Product Change Notification: CENO-21SVWM900

CCB 7196.028 Initial Notice: Qualification of MTAI as new final test site for selected ATtiny261A, AT89LP2052, AT89LP4052, AT89C2051, ATtiny2313, AT89C4051, ATtiny861A, ATtiny2313A, ATtiny26 and ATtiny4313 device families available in 20L PDIP (.300in) package.

PCN #: CENO-21SVWM900

Pre and Post Change Summary -TUBE

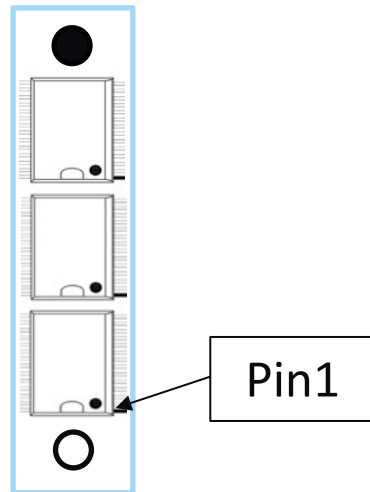
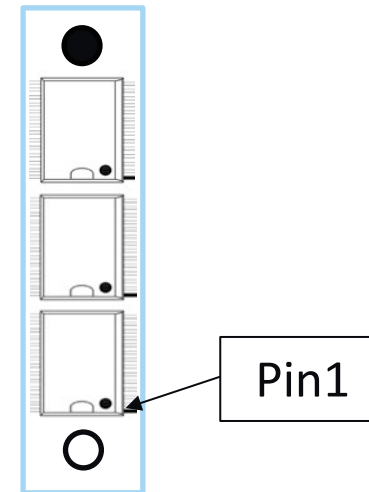
Media	Pin1 Side Color	Opposite Side Color
Pin	White	Black

Media	Pin1 Side Color	Opposite Side Color
Pin	White	Black

PACKING METHOD (BAG)

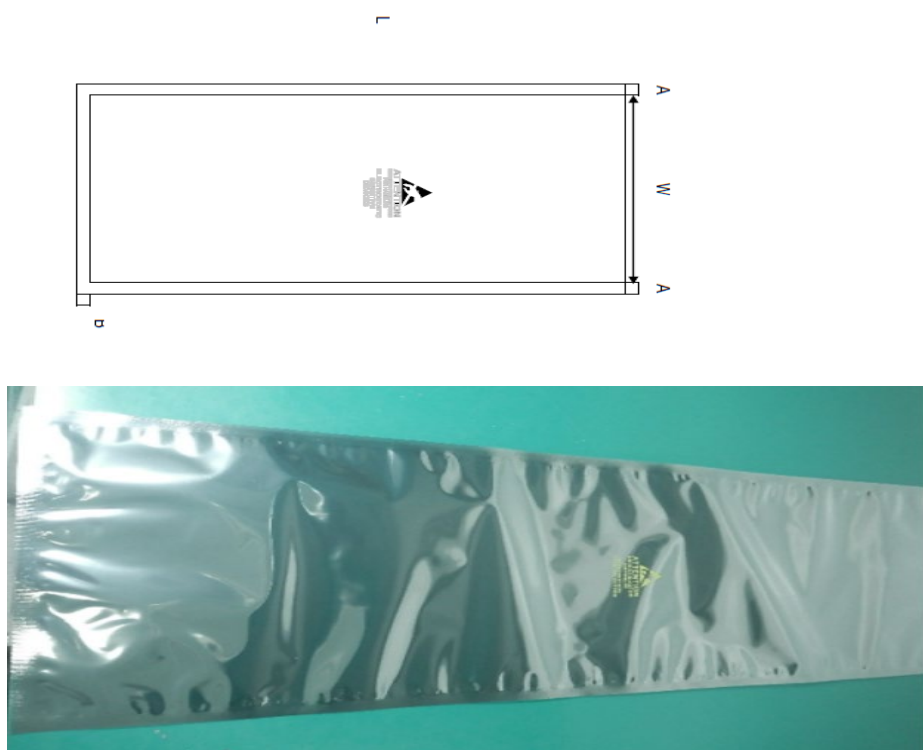
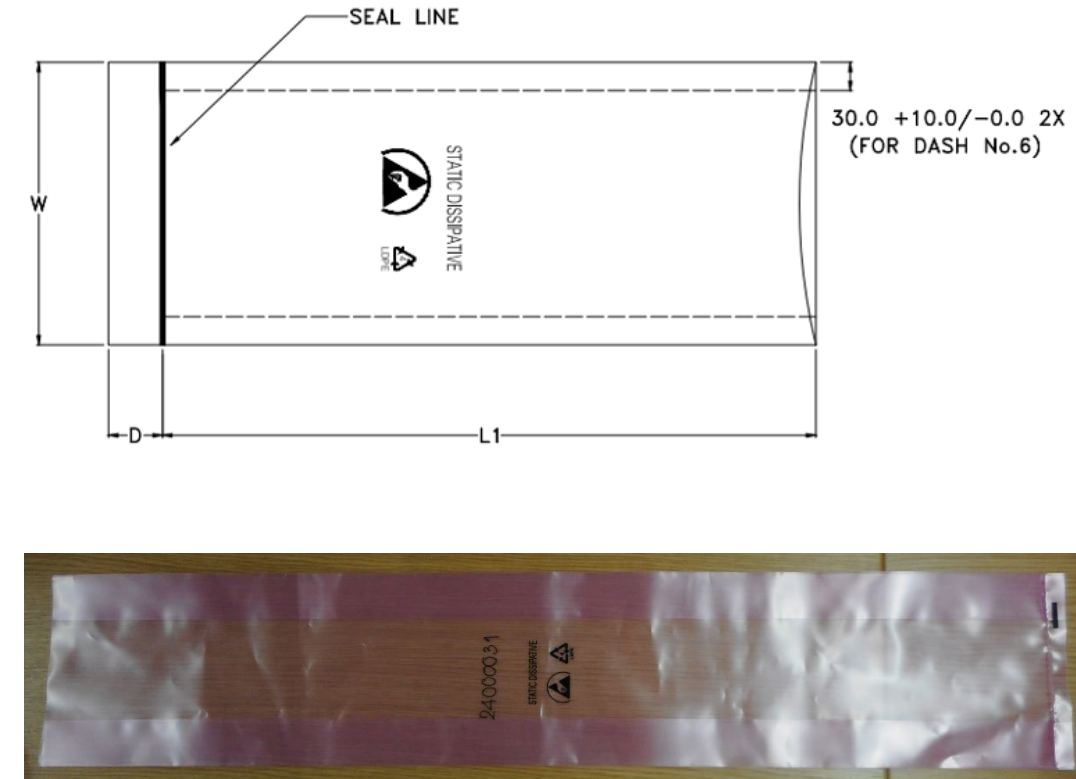
Final Test Site	Bag type	Length (mm)	Width (mm)	Thickness (mm)
MPHL	Static Shielding Bag (Gray)	762 +/- 10	228 +/- 10	0.08 +/-0.01
MTAI	Antistatic Pink Gusset	760 +10/-5	140 +10/-0	0.100 +/- 0.01
